## Todd Prager & Associates LLC

### MEMORANDUM

**DATE:** September 5, 2024  
**TO:** Sam Nisley (Vaughn Bay Construction)  
**FROM:** Todd Prager, RCA #597, ISA Board Certified Master Arborist  
**RE:** Tree Removal at Cascade Creek Apartments

**PROJECT:**  
CASCADE CREEK APARTMENTS  
38272 OR-211  
SANDY, OR 97055

Attachment 1: Civil Plan Sheet with the Four Trees Requested for Removal

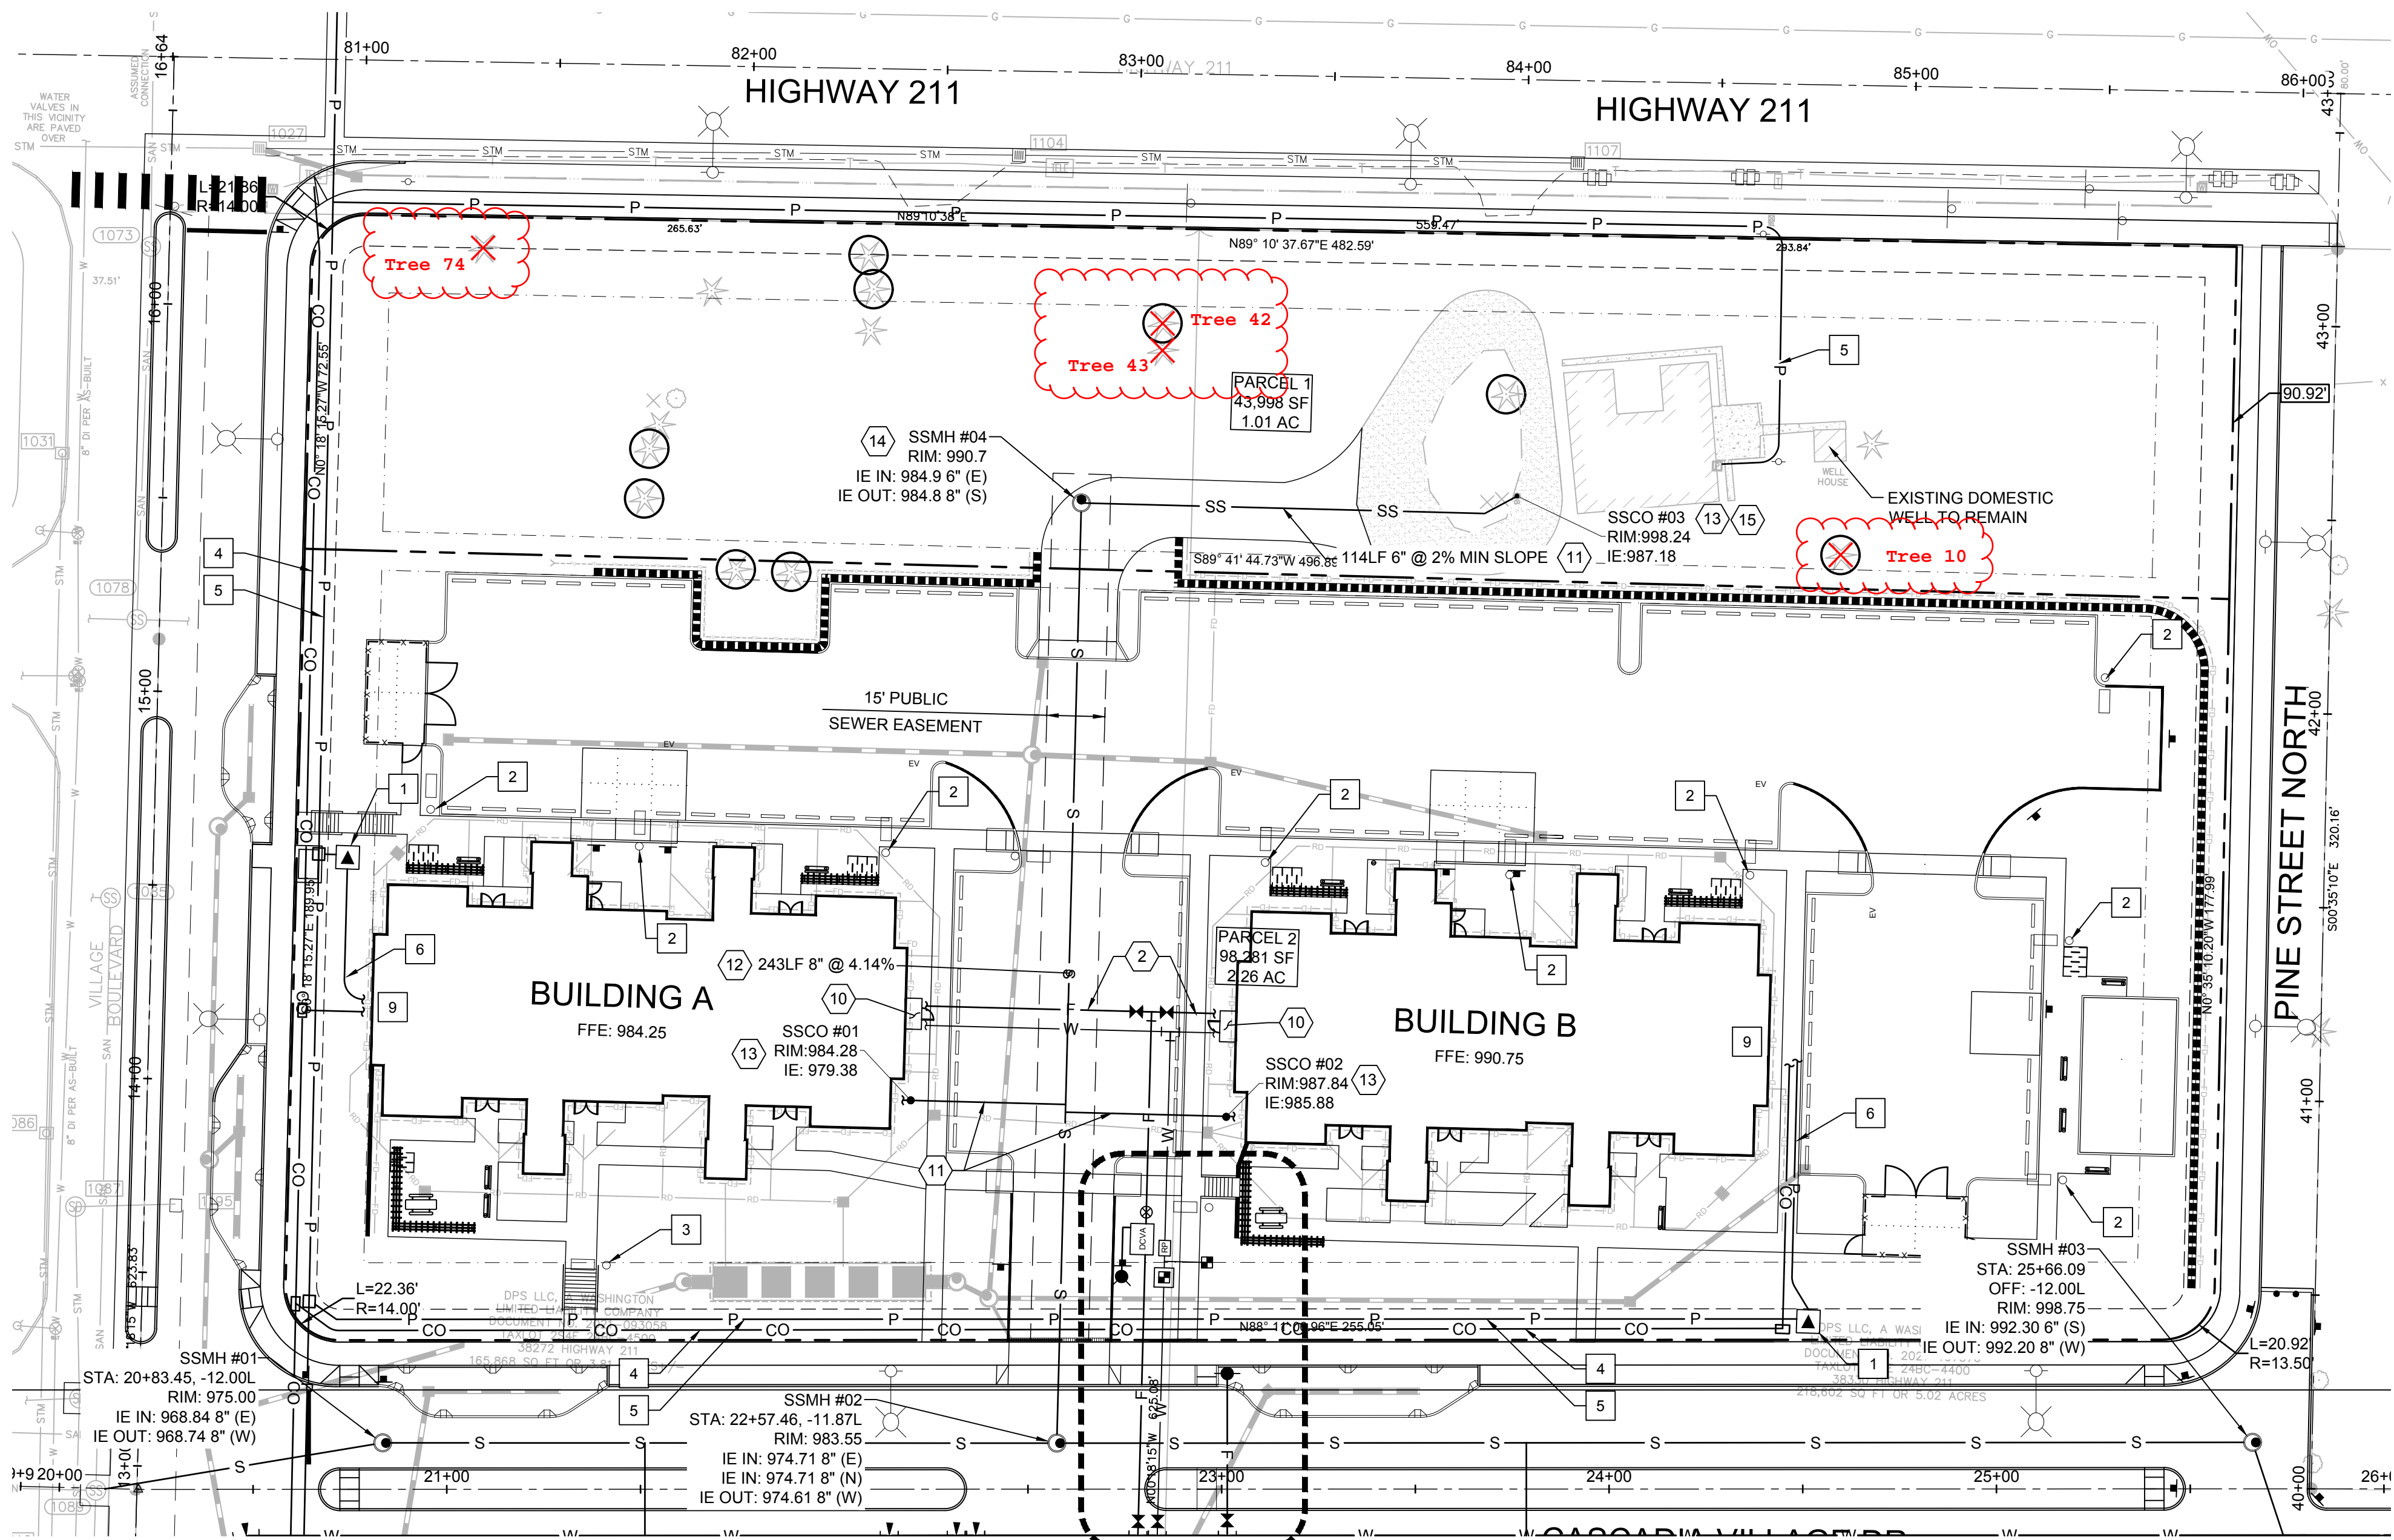
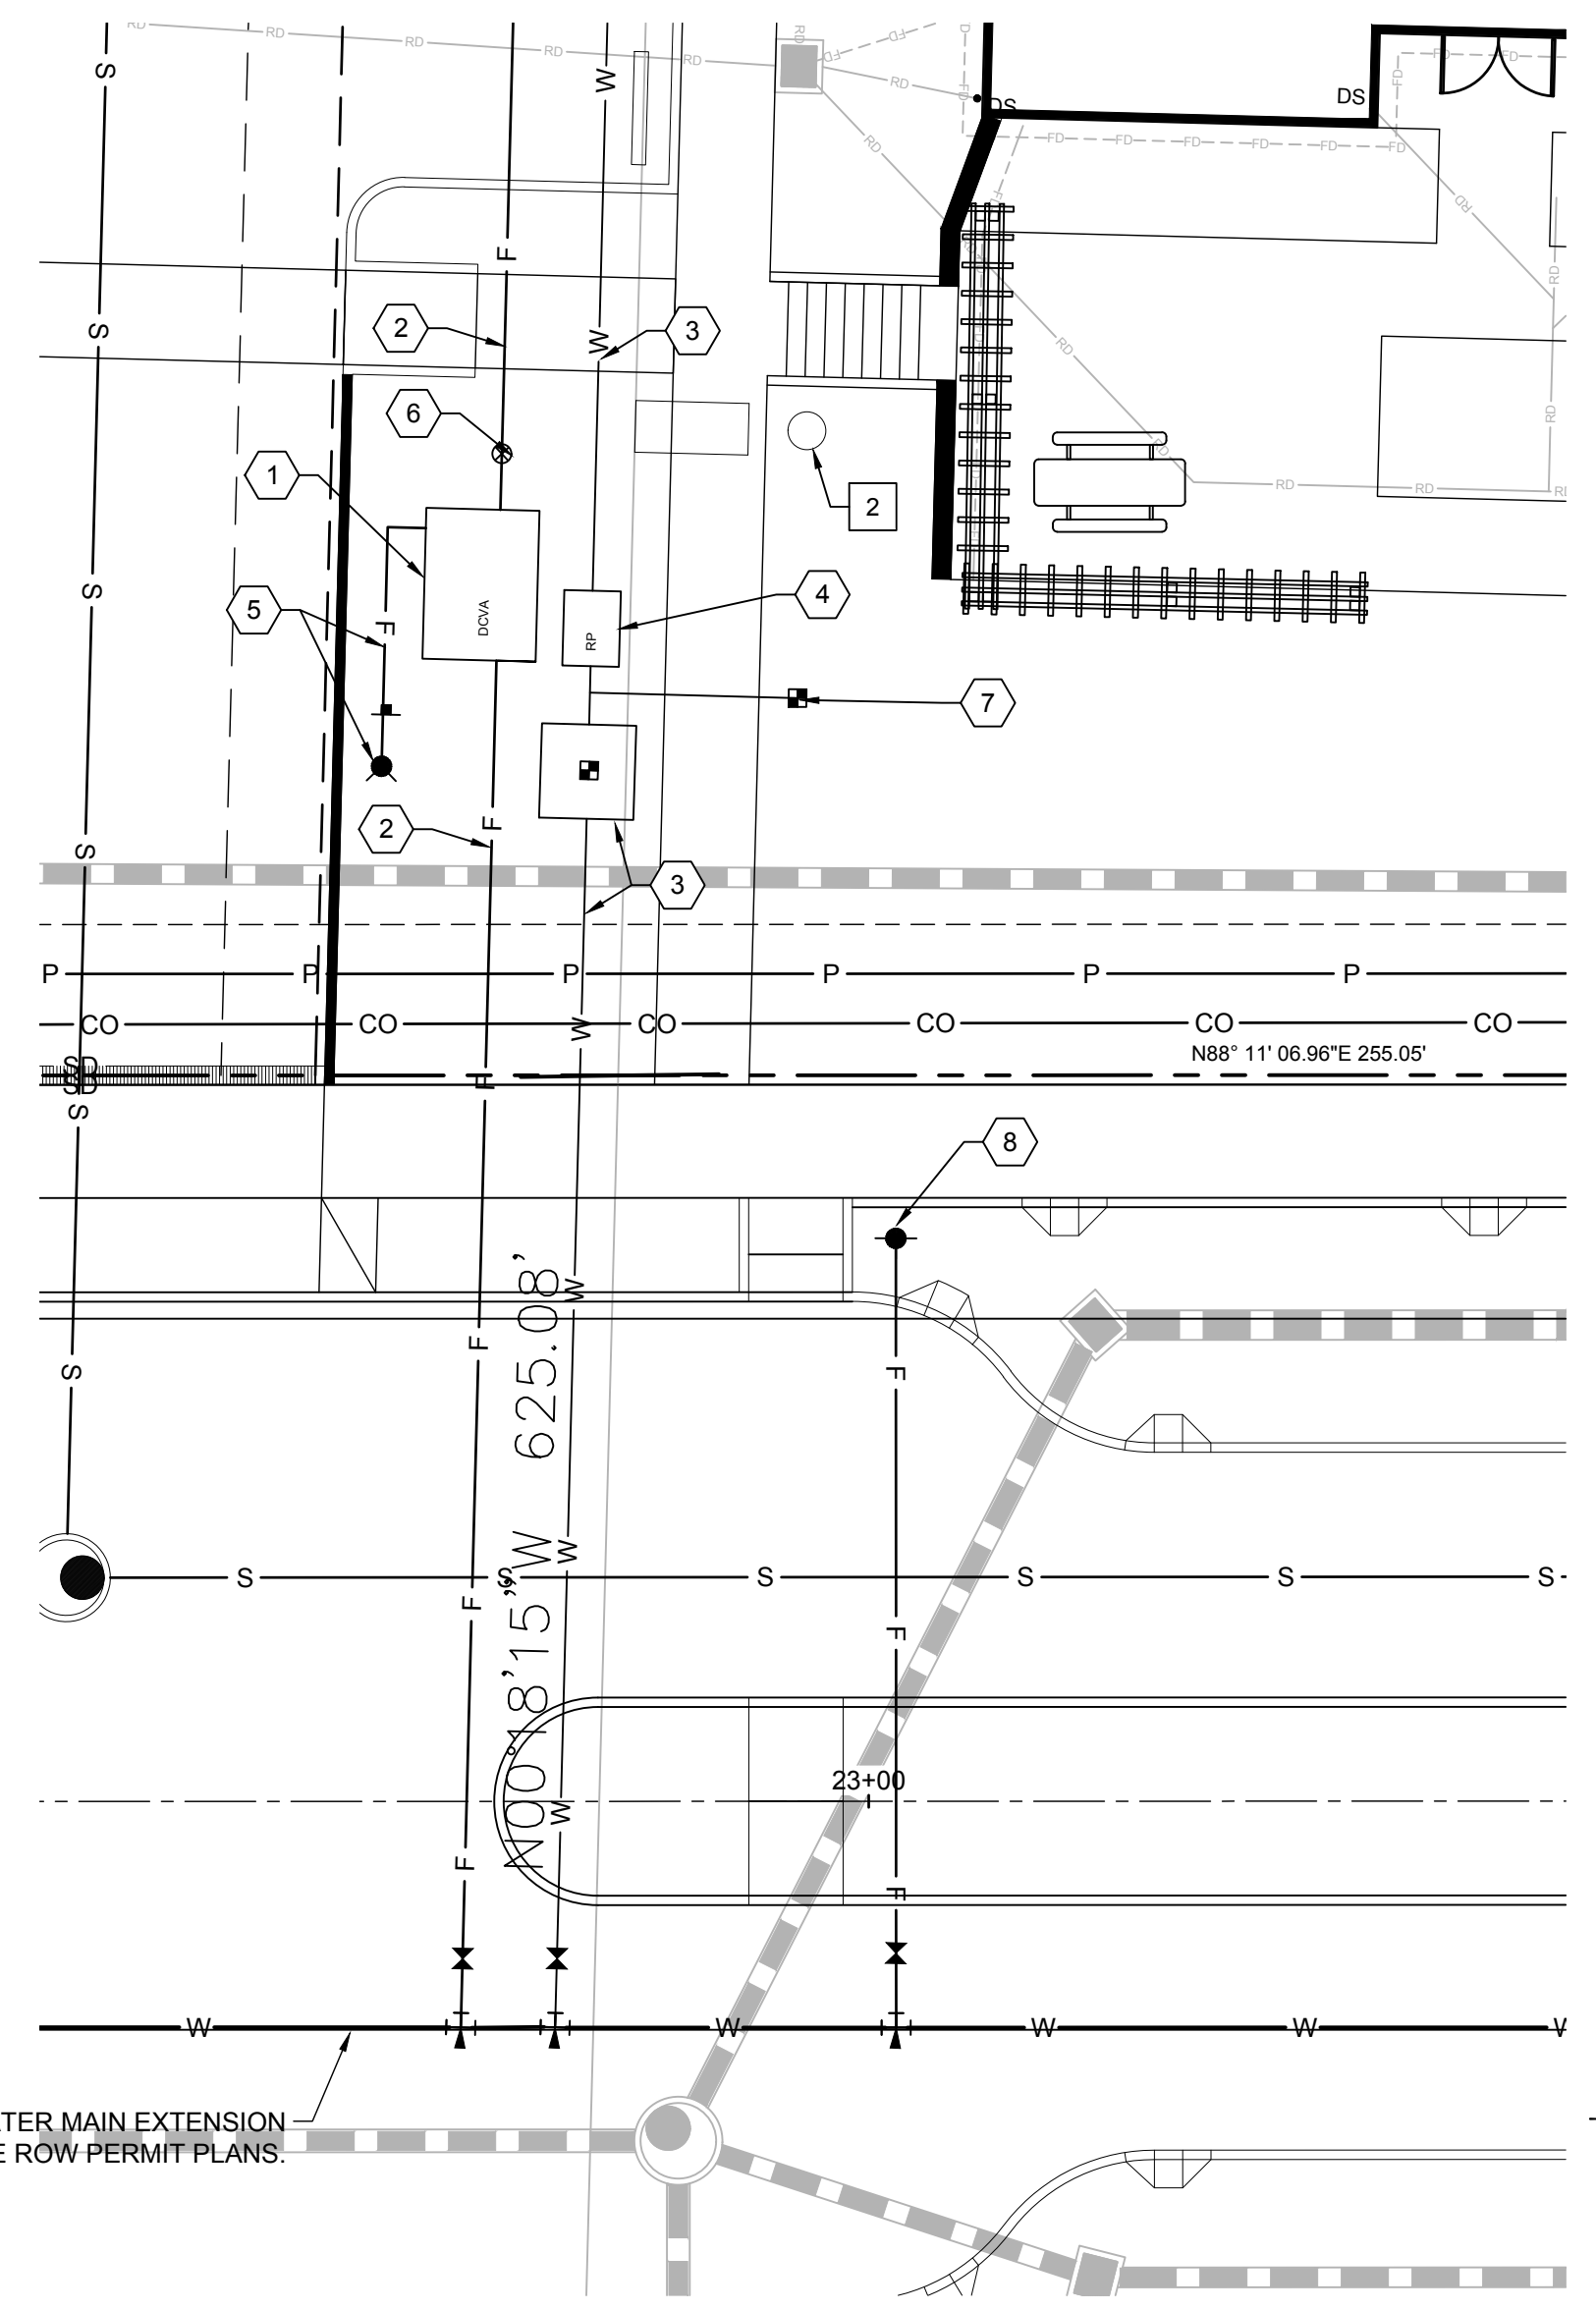
Vaughn Bay Construction is requesting the removal of four trees at the Cascade Creek Apartments site. The civil plan sheet with the four trees requested for removal is in Attachment 1. The trees requested for removal and the reasons are summarized in Table 1.

Tree #	Common Name	Scientific Name	DBH	Condition	Retention Tree?	Reason for Removal
10	blue atlas cedar	<i>Cedrus atlantica</i>	21	good	yes	tree location error, wall is one foot south of the face of trunk
42	ponderosa pine	<i>Pinus ponderosa</i>	12	fair	no	increased risk of windthrow after removal of surrounding trees
43	ponderosa pine	<i>Pinus ponderosa</i>	10	fair	no	increased risk of windthrow after removal of surrounding trees
74	Douglas-fir	<i>Pseudotsuga menziesii</i>	9	fair	no	tree location error, sidewalk is directly adjacent to north side of trunk

This lack of survey for tree locations may explain the discrepancies and conflicts associated with trees 10 and 74 on the civil plans when compared with their locations at the site.

In summary, three of the four trees requested for removal are not retention trees. Tree 10 requested for removal is a retention tree. The specific location of tree 10 was not surveyed, and appears to be in conflict with a proposed retaining wall based on markings at the site.
